Macquarie University Arts Precinct Project

FACADE DIAGRAM LEVEL 6 - 25 WW B LEVEL 4 - 25 WW C

SSDA-56 checked

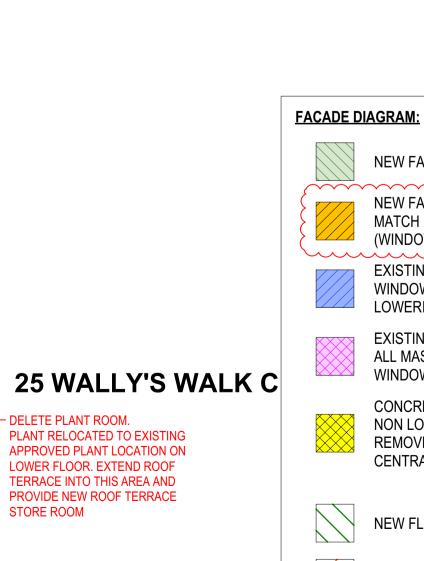
PLANT RELOCATED TO EXISTING APPROVED PLANT LOCATION ON LOWER FLOOR. EXTEND ROOF TERRACE INTO THIS AREA AND PROVIDE NEW ROOF TERRACE STORE ROOM

DELETE PLANT ROOM. —

RELOCATE COOLING TOWERS AND PUMPS TO ——— MODIFY CURRENTLY APPROVED ROOF —— TERRACE DESIGN TO IMPROVE FUNCTIONALITY 25WWA EASTERN WING ROOF.

— RELOCATE PLANT TO ROOF LEVEL.

RE-USE AREA AS MARKED.

NEW WINDOWS AS SHOWN.

MODIFY CURRENTLY APPROVED ROOF—— TERRACE DESIGN TO IMPROVE FUNCTIONALITY AREA TO BE REUSED AS EXPANDED ROOF TERRACE.

RELOCATE COMMS RISER.

EXTEND GLAZED FACADE AND COLLABORATIVE SPACE.

RELOCATE PLANT TO ROOF LEVEL. ——

RE-USE AREA AS MARKED. NEW WINDOWS AS SHOWN.
